MEMO TO: City of Bayonne Planning Board

FROM: Malvika Apte, PP/AICP
Consulting Planner

DATE: March 28, 2022

**RE: Gauri Shankar Flagship Urban Renewal, LLC
Preliminary Major Site Plan
Planning Report # 1
Block 751 Lot 1.06
54 Flagship Street
Bayonne, New Jersey
Our File: PBYP0751.04
Application # P-21-002**

Parcel B- approved per GDP

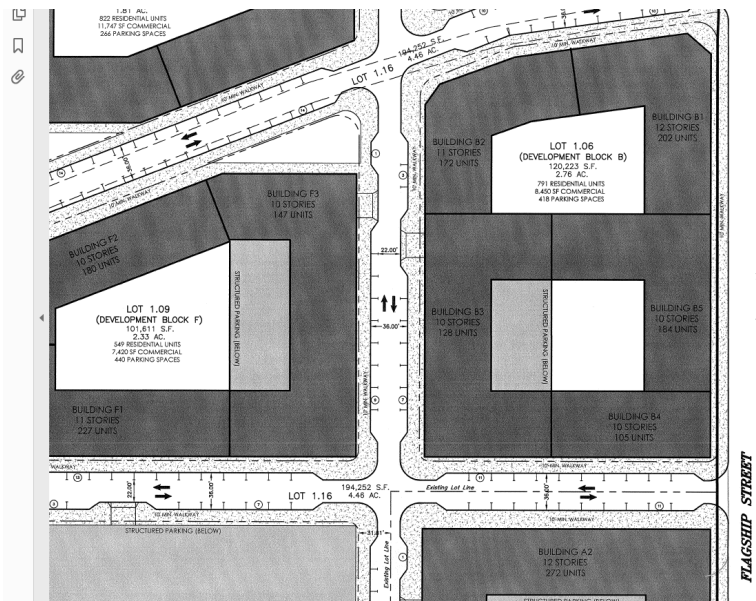
With this proposal applicant, appears to propose “first phase” of the parcel. This should be clarified, along with the schedule for the rest of the block including parking structure. This proposal includes 159 units, 8,745 square feet of commercial space and 120 surface parking spaces and 46 garage parking spaces.
